PLANNING COMMISSION VOTE REPORT

Subject: Ordinance Amendment Vote Report

Petition: P.Z. 06-2013 Mercy Health Systems (Chesterfield Village, SE Quadrant)

RE: *Mercy Health, P.Z. 06-2013 ("Application for Zoning Amendment")*

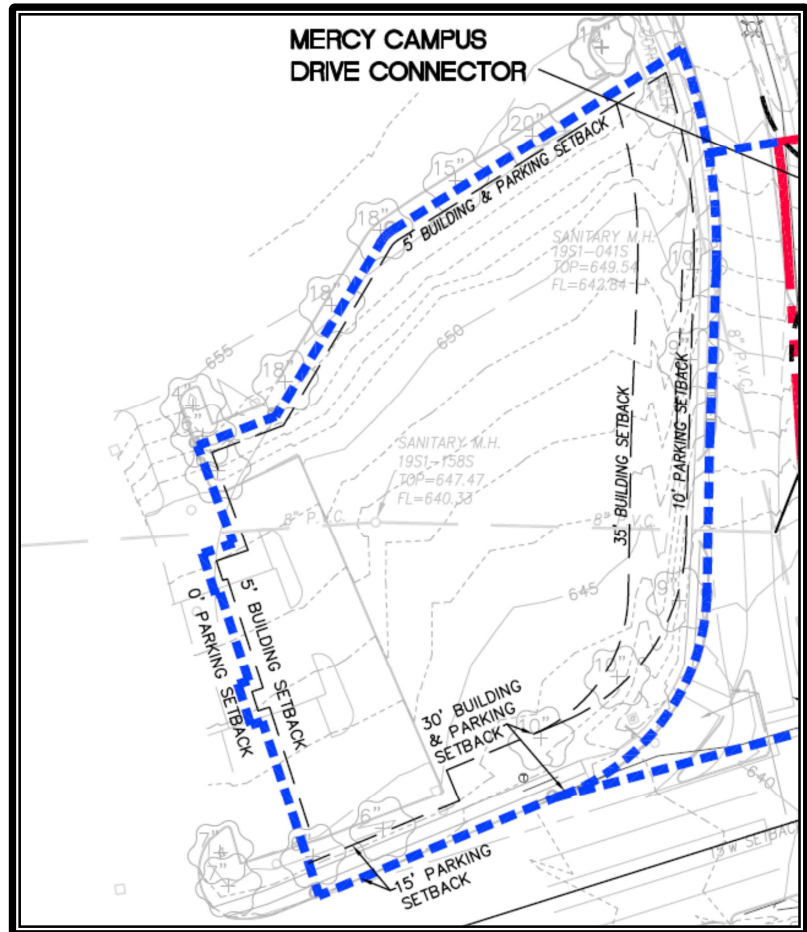
Issue #1

The first issue related to the setback along Chesterfield Parkway for one of the parcels proposed to be included in the "UC" District. The graphic on the previous page depicts this additional area in yellow.

This issue was raised during the establishment of the initial "UC" District for the development. At that time, an increased buffer along Chesterfield Parkway was agreed upon where the southern setback would be increased and the western setback would be reduced. This created a larger separation between the proposed development and the residential properties located on the south side of Chesterfield Parkway while allowing a smaller buffer between the commercial properties to the west.

The Preliminary Plan presented to the Commission at the Public Hearing showed a 15 foot parking and building setback along this property. After receiving the concerns raised at the Public Hearing, the Petitioner is proposing to increase the proposed setback to 30 feet. Please note that the parking setback, at the request of Staff, has been modified to allow the existing parking on the site to remain in compliance with the ordinance amendment under review by the Commission. The increase in the buffer would create a larger buffer along Chesterfield Parkway while still retaining a buildable lot. The Petitioner's response to the issue (attached) states that, "a greater setback would render this Southern addition unbuildable." Please note, **the proposal does not impact the previously approved setback along Chesterfield Parkway or any other previously approved setbacks as part of the Mercy development.**

Issue No. 1: The additional property identified with Locator 19S531922 (the "Southern Addition") is currently a buildable lot in an approved subdivision. Petitioner has proposed a fifteen (15) foot setback from the southern boundary of the Southern Addition. Petitioner can increase this setback to thirty (30) feet from the southern boundary of the Southern Addition. A greater setback would render this Southern Addition unbuildable. The setback for the southern boundary of the UC District would remain one hundred (100) feet except for the southern boundary West of Elbridge Payne Road where the setback would be thirty (30) feet.

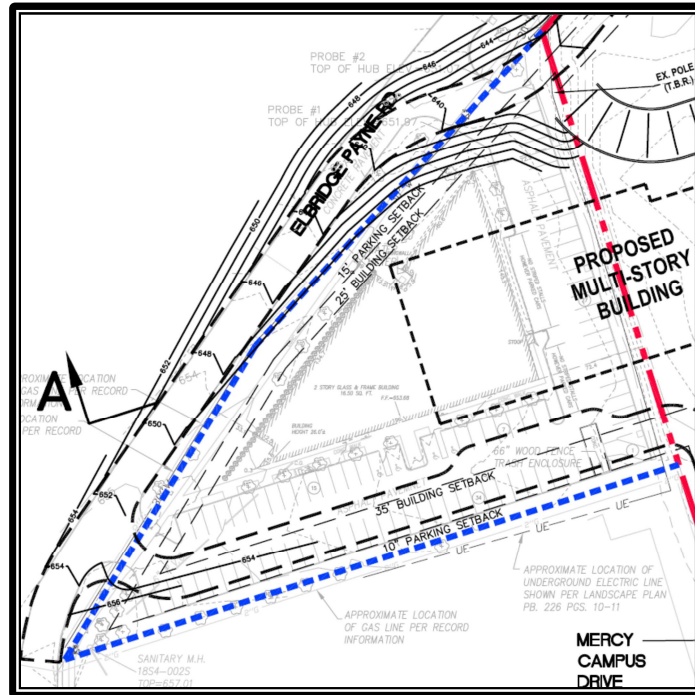
Issue #2

The second issue related to clarification of the proposed setback for the northern property. The Preliminary Plan presented at the Public Hearing showed a 20 foot setback along the northwestern property line. After receiving the concern about the setback and reviewing the existing regulations with Staff, the Petitioner is proposing to increase this setback to 25 feet to match the existing regulations on the building.

Issue No. 2: The additional property identified with Locator 18S210138 (the "Northern Addition") is currently occupied with a building that will eventually be removed and replaced with a new building. The current preliminary plan shows that the conceptual footprint of the building will result in more open space facing Clarkson Road than is currently provided except for one corner where the conceptual footprint will be closer to Clarkson Road than the existing building. The setback for building and parking along the northern boundary of the UC District can be thirty-five (35) feet except for 560 feet of the northwestern boundary adjacent to Elbridge Payne Road where the setback would be twenty-five (25) feet.

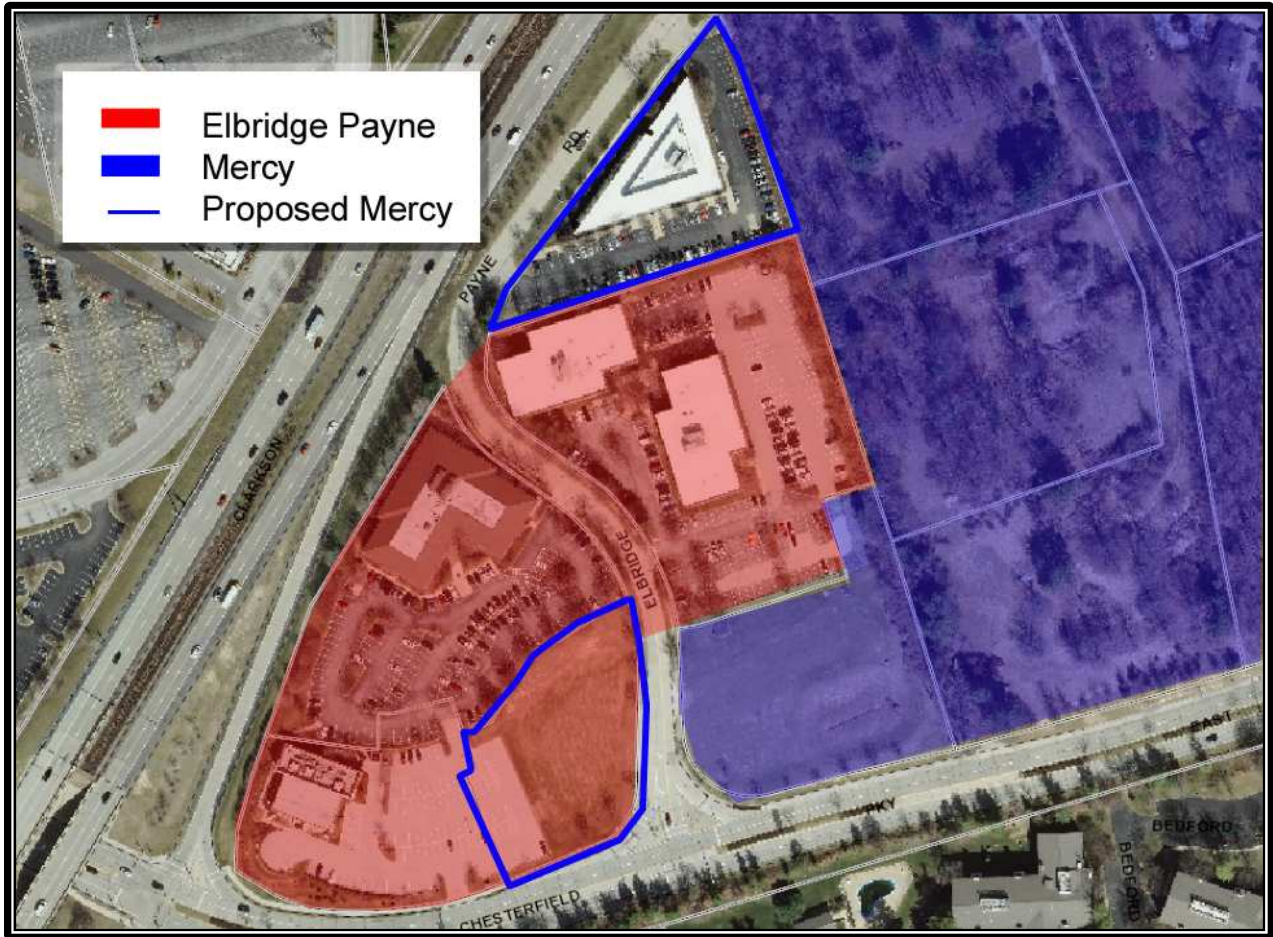
Impact to Elbridge Payne Density

City of Chesterfield Ordinance 2412, which governs the Elbridge Payne development, allows (in part) for:

A maximum of 170,000 square feet of office space to be included in not more than six (6) buildings; and, one free standing restaurant not to exceed 15,000 square feet.

The image on the next page shows the areas currently regulated by this requirement, a portion of the Mercy development, and the area currently in Elbridge Payne proposed to be encompassed in the Mercy development.

There are currently three office buildings and one restaurant located within the Elbridge Payne development. The office buildings in the development total approximately 111,000 square feet of floor area. Under the previous density discussed on the previous page, the vacant parcel proposed to be included in the Mercy development would be permitted approximately 59,000 square feet of floor area. By including this land area in the Mercy development, an additional approximately 31,360 square feet of floor area would be permitted in the Mercy development.

The existing “triangle” building is regulated under St. Louis County Ordinance 11,323 which permits a maximum of 26,900 square feet of development on the parcel. The Preliminary Plan to include this parcel proposes demolition of the existing office building and a portion of a new building being constructed on the site.
